**4. REZONING: 2220 Kingsway**

**Summary:** To rezone 2220 Kingsway from C-2 (Commercial) District to CD-1 (Comprehensive Development) District. The proposal is for a mixed-use development comprised of a commercial podium and three 14-storey residential towers containing a total of 404 dwelling units. A floor space ratio (FSR) of 3.8 and a building height of 45.1 m (148 ft.) are proposed.

**Applicant:** Brock Cheadle, Henriquez Partners Architects

Diagram 1

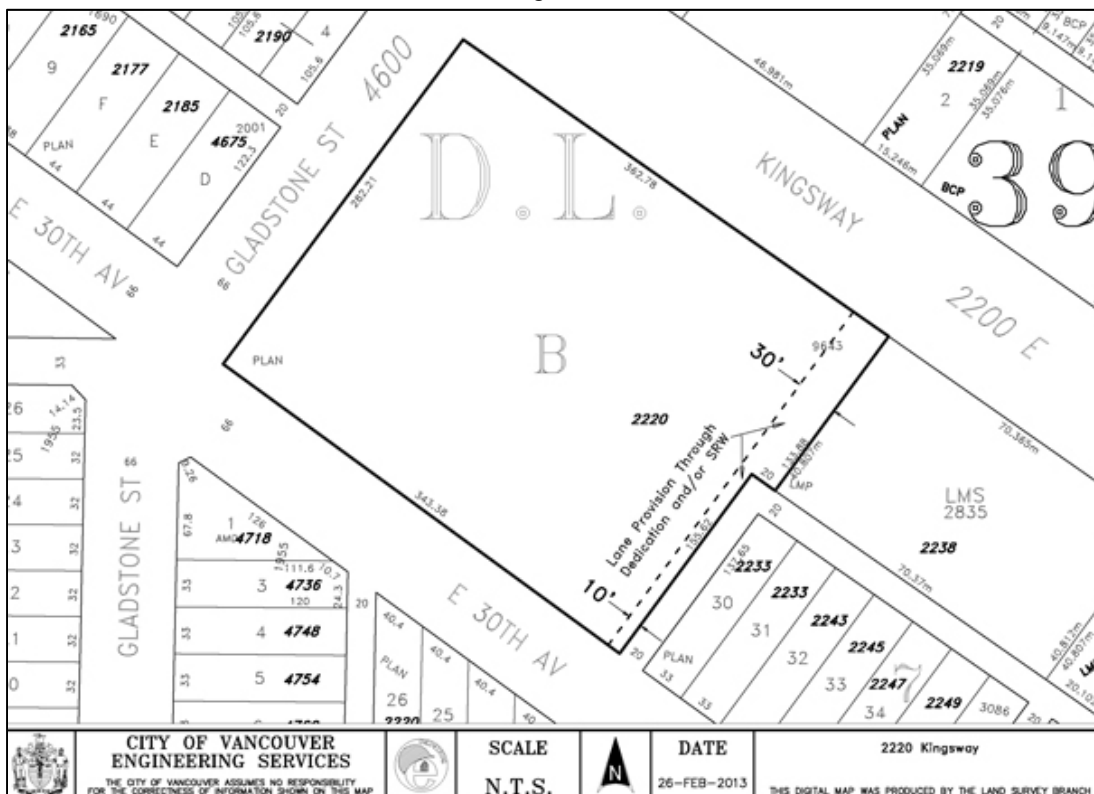
1. Creation of a 30-foot wide lane along the eastern edge of the site for vehicular access and to provide a pedestrian corridor and connection from Kingsway to 30th Avenue through provision of dedications or through other means acceptable to the General Manager of Engineering Services and the Director of Legal Services. See Diagram 1, below.
